PARKWAY HEIGHTS MIDDLE SCHOOL MODERNIZATION - PHASE II PROJECT 01-18

Addendum 01

FEBRUARY 15, 2018

**ADD 1
01.10**

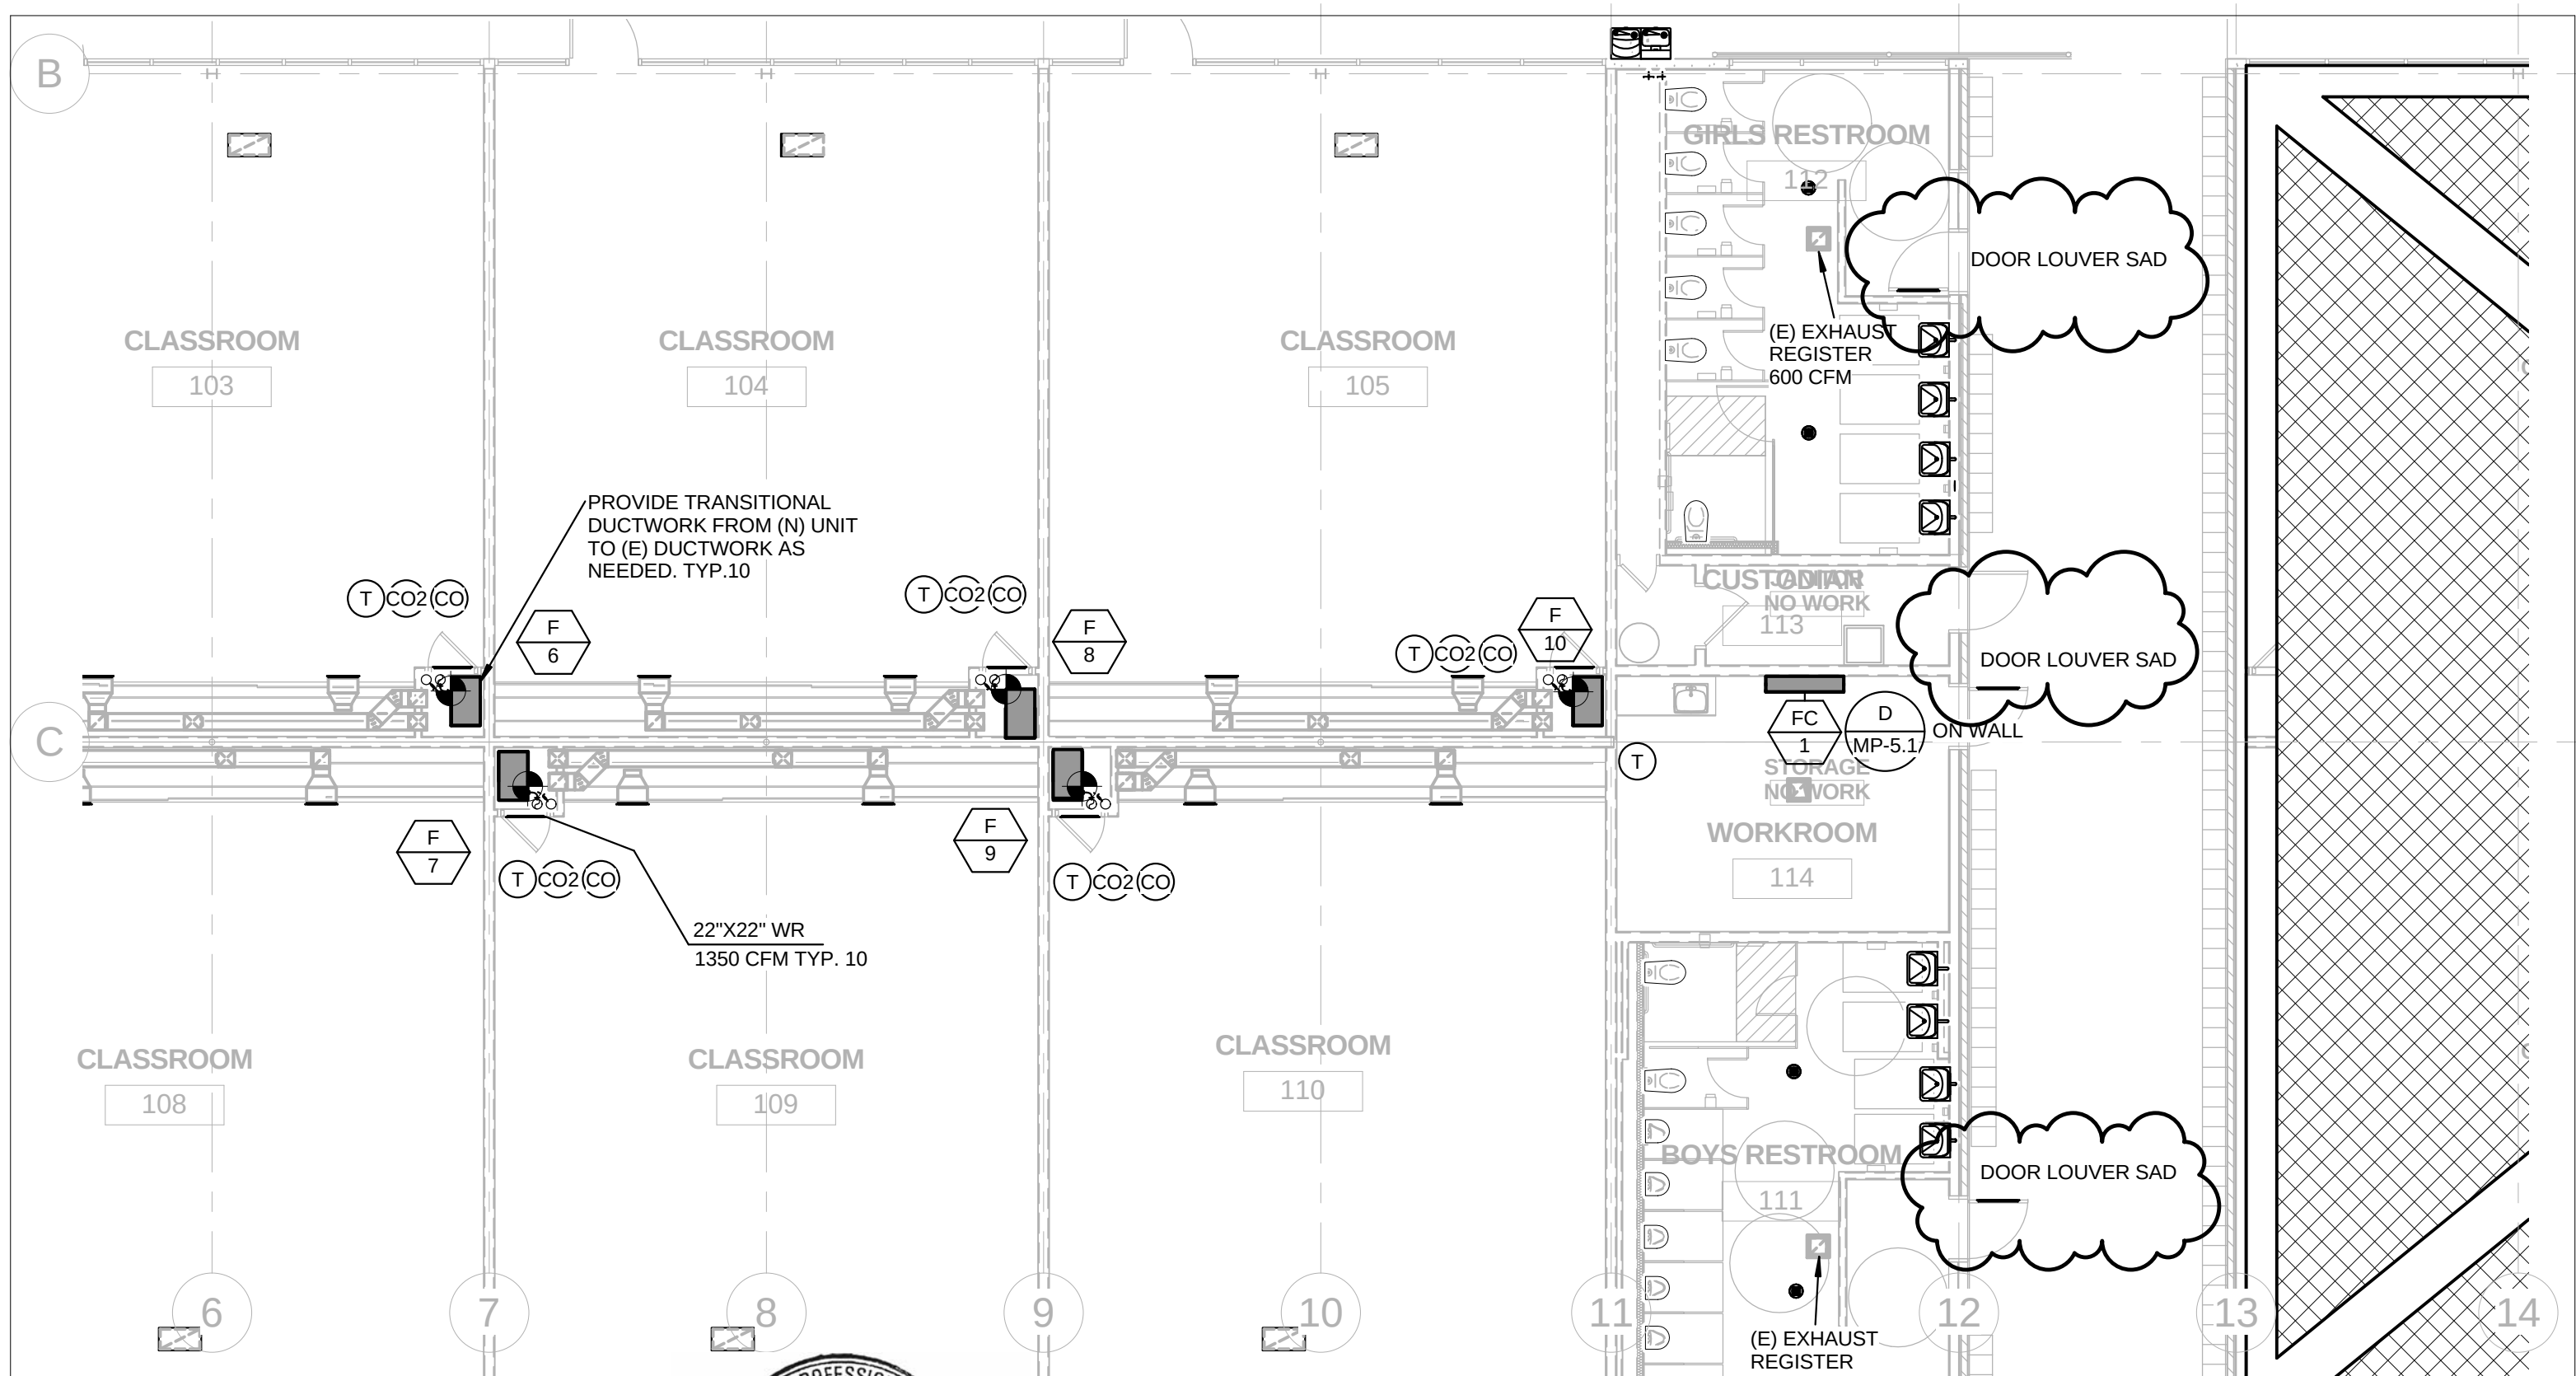
Louvers noted. See Add 01.10
